COUNCIL ASSESSMENT REPORT

SNPP No	PPSSNH-362
DA Number	LDA2022/0408
Local Government Area	City of Ryde
Proposed Development	Demolition and construction of a 14-storey mixed use development comprising commercial premises at the ground level fronting Herring Road, 307 residential apartments, 4 basement parking levels and associated communal open space areas including a pool, landscaping, stormwater management works, public domain works and stratum subdivision.
Street Address	5-11 Lachlan Avenue & 155-159 Herring Road Macquarie Park
Applicant/owner	Applicant: One GC MQ Park Pty Ltd C/- Urbis Owner: The owners of: <ul style="list-style-type: none"> • SP 12698 (5 Lachlan Avenue); • SP 14550 (7 Lachlan Avenue); • SP 22475 (9 Lachlan Avenue); • SP 6760 (11 Lachlan Avenue); • SP 6782 (155 Herring Road); • SP 6956 (157 Herring Road); and • SP 16663 (159 Herring Road).
Date of Lodgement	15 December 2022
Number of Submissions	3 submissions objecting to the proposal

<ul style="list-style-type: none"> • State Environmental Planning Policy No. 65 – Design Quality of Residential Apartment Development; • Ryde Local Environmental Plan 2014; • Ryde Development Control Plan 2014; and • Section 7.11

Figure 16 – Cross section through balconies/planter boxes (Tower A).

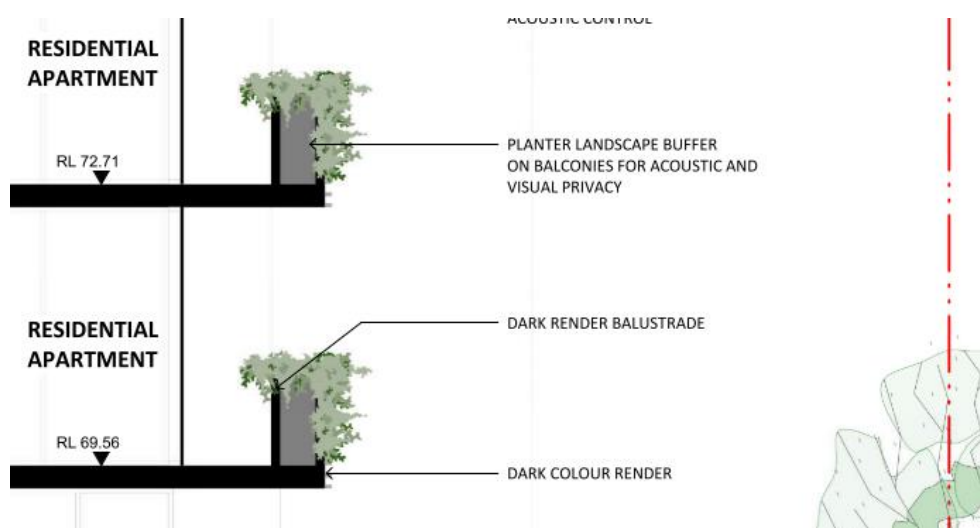
- *Planter beds shown on these indented balconies are adequately sized to support meaningful vegetation.*
- *The planter bed integrated above the retail awnings is adequately sized to support climbing vegetation (and that environmental conditions are favourable to plant growth, and that a viable maintenance regime exists).*

The balcony planter boxes have a depth of 1.1m and an internal width of 0.4m which is considered sufficient to plant shrubs of any meaningful volume and appearance.

The applicant has submitted plans which detail the wind resistant species and irrigation method used in balcony planter boxes (see landscape plan 601). Notwithstanding, these matters included in a condition to ensure they're enforced in Construction Certificate drawings (see **Condition 64** in the draft consent).

Figure 18 – View from the sun at 9.00am on 21 June.

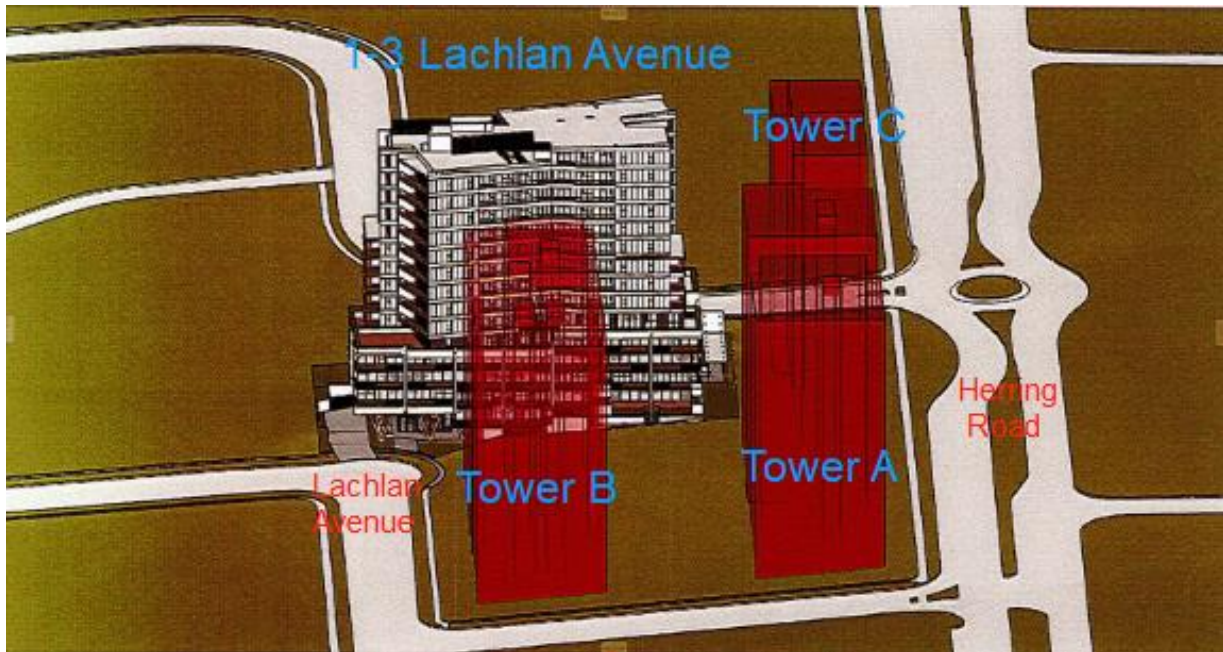
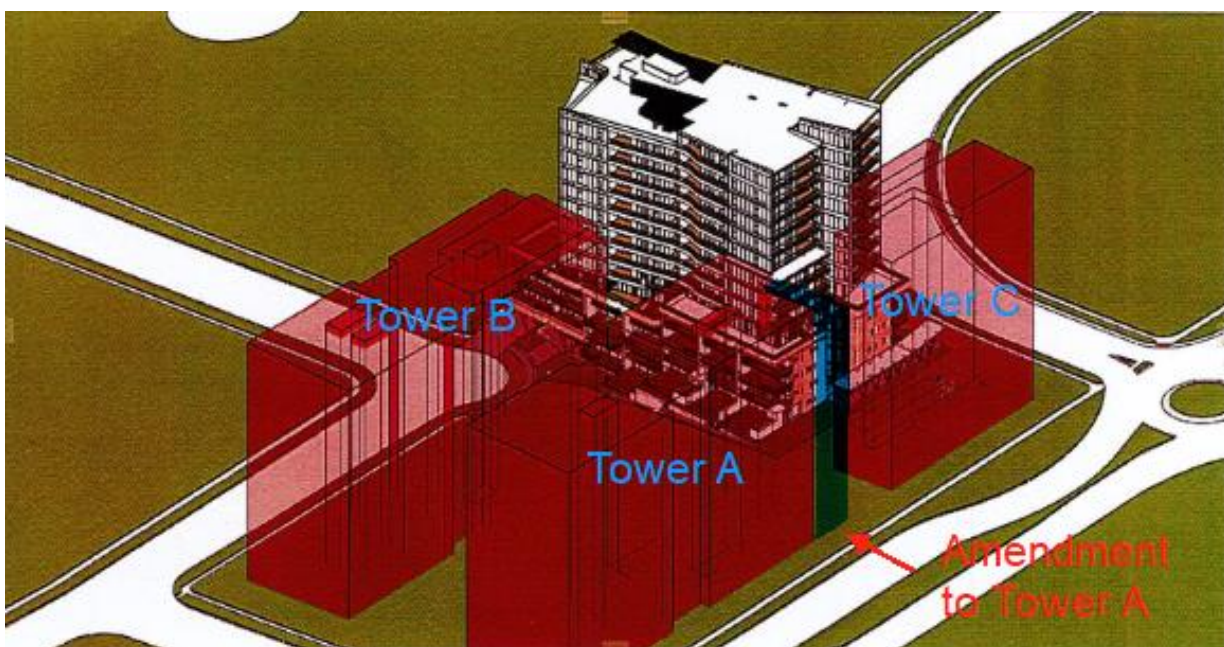
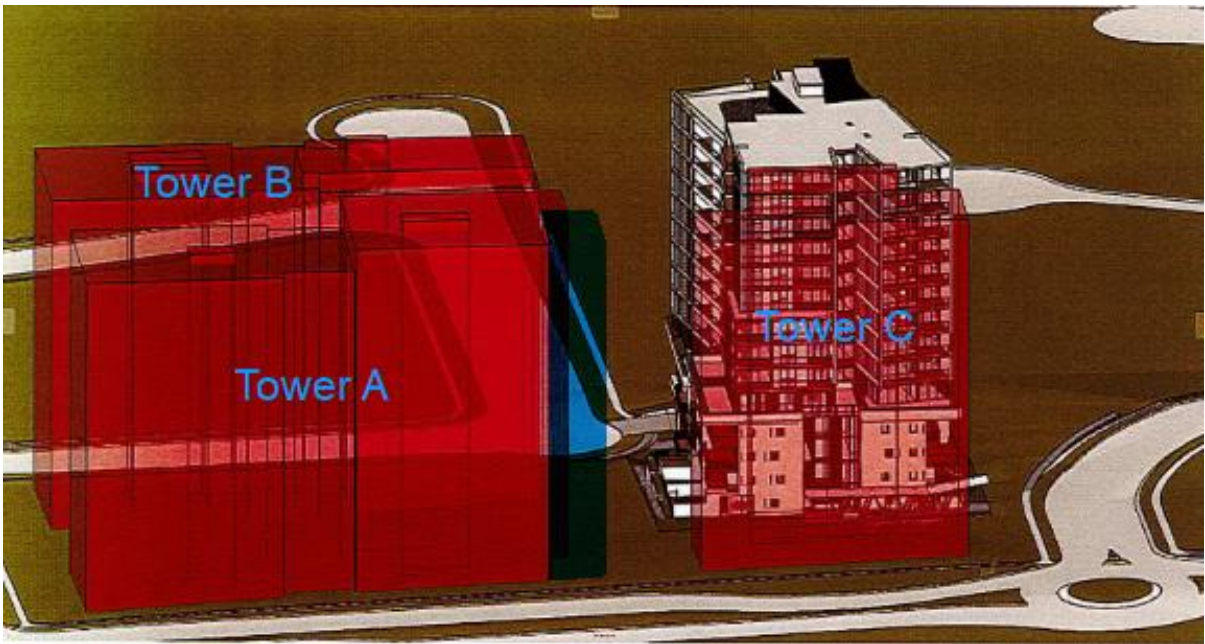
Although Clause 3B does not specify a time period, **Figures 18 to 20** show the impact of the development on 1-3 Lachlan Avenue at 9.00am, Noon and 3.00pm on 21 June. The red shading indicates the development as originally lodged, the blue shading indicates the amendment to Tower A.

Therefore, it is considered that the impact of the development is not regarded as unreasonable and that the departure from the design guidance under Objective 3B-2 can be supported.

Figure 21 – Recommended building separations.
Source: Adapted from Plan A0300 (Rev E) as prepared by Kiochi Takada Architects.

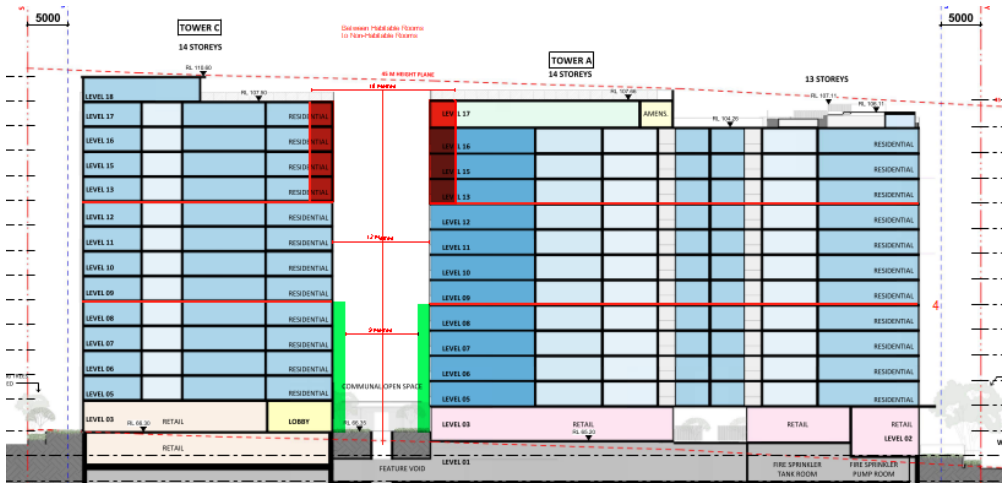
Tower A to Tower C has a building separation of between 12m and 22.6m. The 12m separation is between habitable rooms and non-habitable rooms. The recommended separation between these rooms is 18m for development 9 storeys and above.

Figure 21 below shows the development subject to strict building separation recommendations between Tower A and Tower C (red indicating where the separation would be increased and green indicating where the separation could be reduced).

Figure 23 – Building separations from Tower C to the approved development at 1-3 Lachlan Avenue.
Source: Adapted from the Site Plan (Rev 03) dated 28 August 2022 as prepared by Bureau SRH.

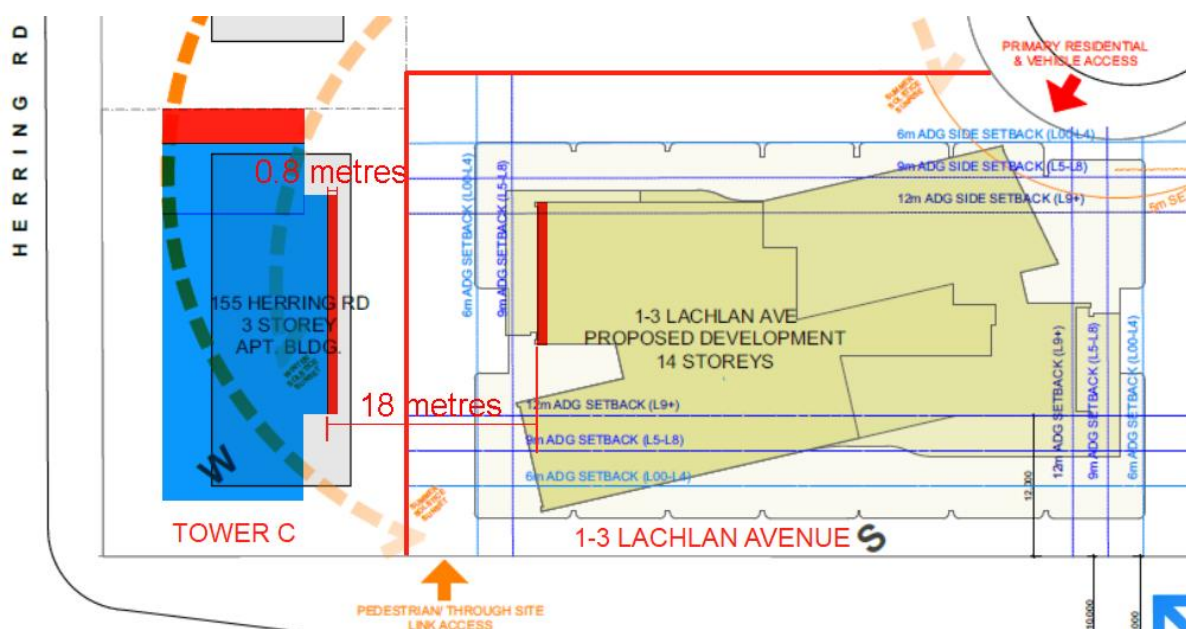
Figure 23 below shows Tower C (shown in blue) and the effect a strict application of building separation (shown in red) because of the separation distances established by the approved development at 1-3 Lachlan Avenue and between proposed Tower A.

As indicated in **Figure 23**, the protrusion of the Tower C (which comprises the service core) into the building separation area is minor and largely a result of the already established building separation of 1-3 Lachlan Avenue and to increase the setback by 0.8m would, as a result, unreasonably penalise Tower C.

Figure 24 – Permitted 45m height plane (in pink) across Towers A, B and C.
Source: Plan A0401 (Rev E) as prepared by Koichi Takada Architects.

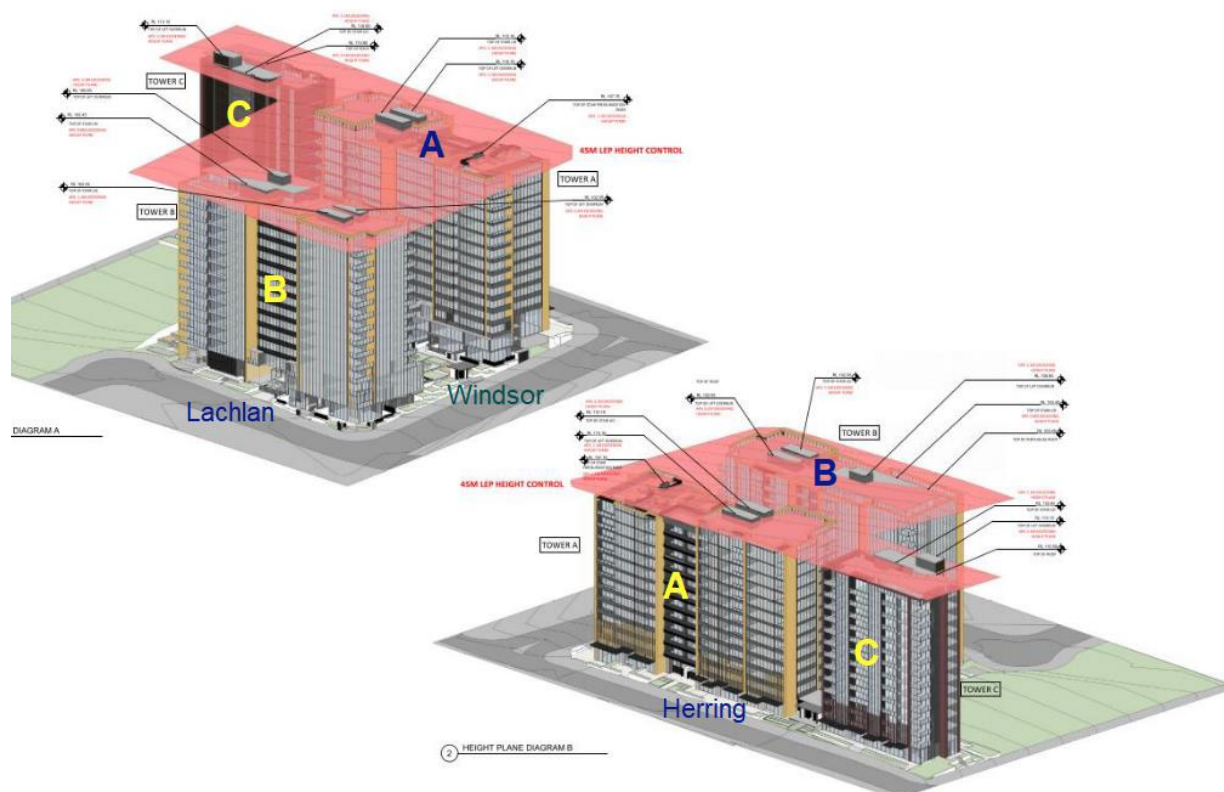
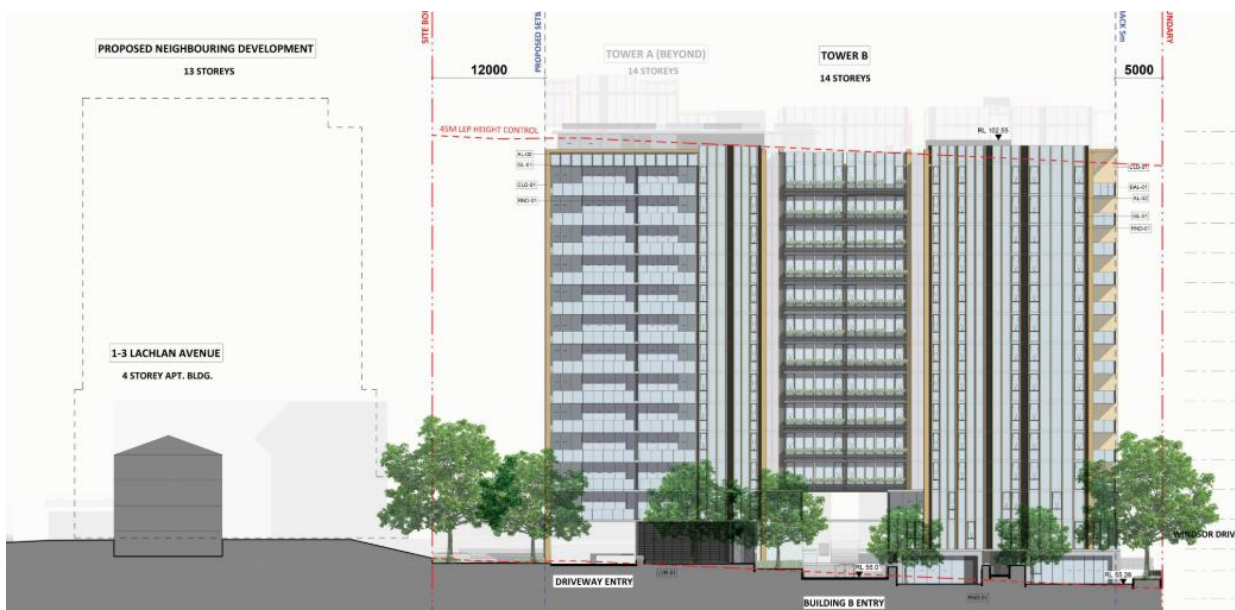
The development proposes building heights of between 47.1m to 48.3m as noted in the table above. The non-compliances vary between 4.7% and 7.3%.

The non-compliant elements are illustrated in **Figures 24 to 26** below where it is noted that the development breaches the permitted building height at the uppermost section of the roof and rooftop plant for all three buildings by varying degree.

A request to vary the Height of Buildings Development Standard has been submitted under Clause 4.6 of the RLEP 2014, as discussed below under Clause 4.6.

Figure 30 - Basement 1 non-compliant front setback.

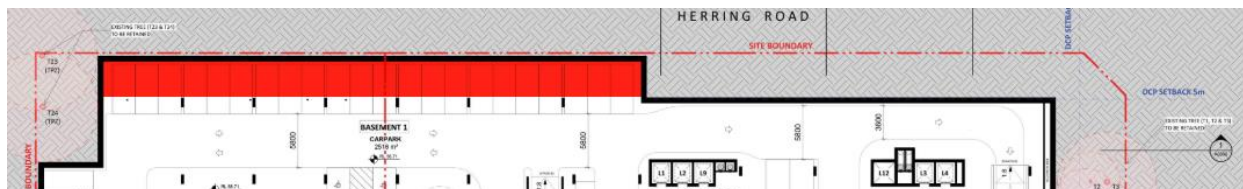
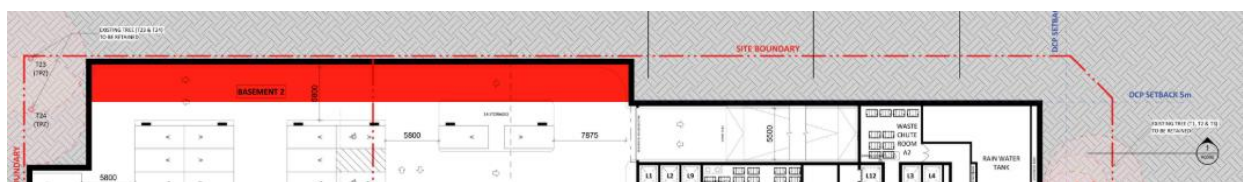
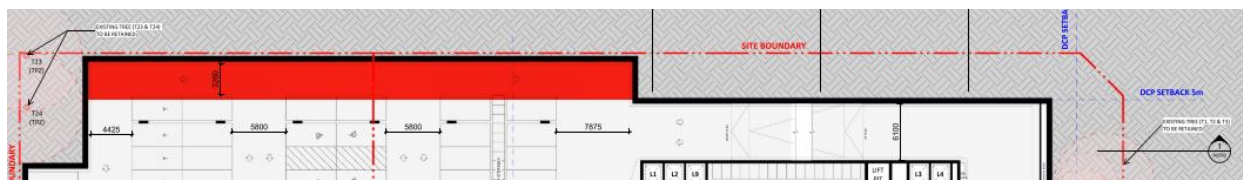
As noted above, the development encroaches within the western side of the property facing Herring Road and extends to 0.3m from the boundary.

Figures 33 to 35 below show the areas (in red) which encroach within the 5.0m setback.

The non-compliance is acceptable in this particular instance as the encroachment is not visible from Herring Road, does not add to the bulk and scale of the development, and enables plantings through the provision of deep soil zones to a depth of 6.0m.

Figure 36 – Cross section through basement levels of Building C.
Source: Plan A0305 (Rev A) as prepared by Koichi Takada Architects.

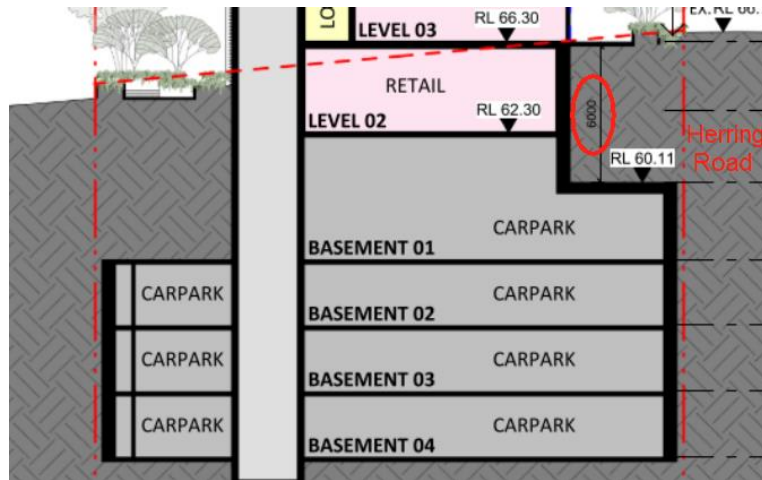
It is noted that Basement levels commence at a depth of 6.0m from street level and that the below ground structures within that depth are set back 5.0m as required as shown in **Figure 36** below.

Figure 37 – Landscape design strategy – Tower C/Herring Road interface.
Source: Landscape Strategy as prepared by Arcadia.

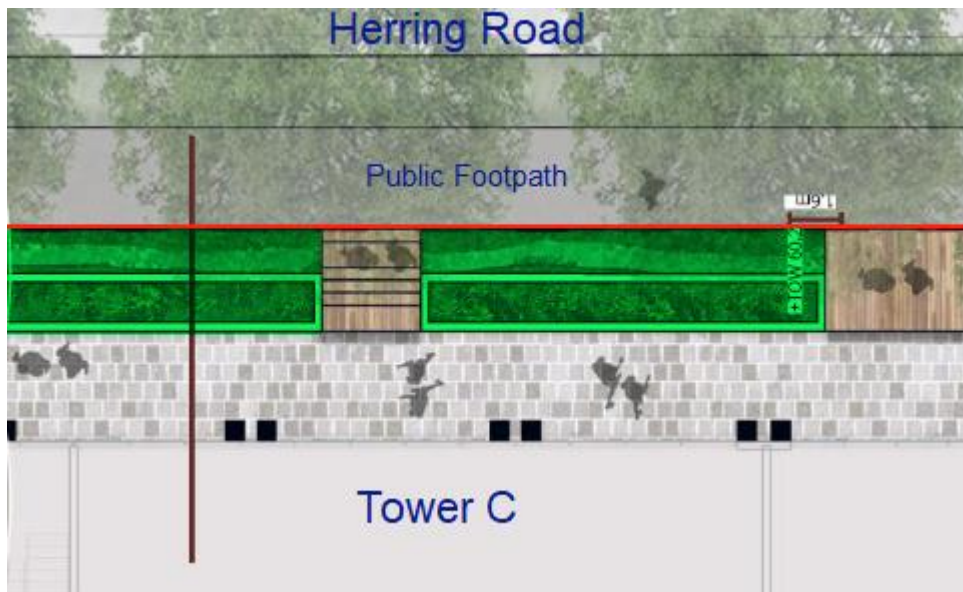
Figure 37 below shows the design intent for the deep soil strip (shaded in green) between Tower C and Herring Road (the red line indicates the property boundary).

Council's consultant Landscape Architect has reviewed the landscape strategy for the development and, with respect to this particular section, has included conditions in the draft consent which requires that the planting areas which adjoin the site boundary fronting Herring Road are to be contiguous, provided entirely at ground level and not impeded by planter walls / hobs (see **Condition 62**).
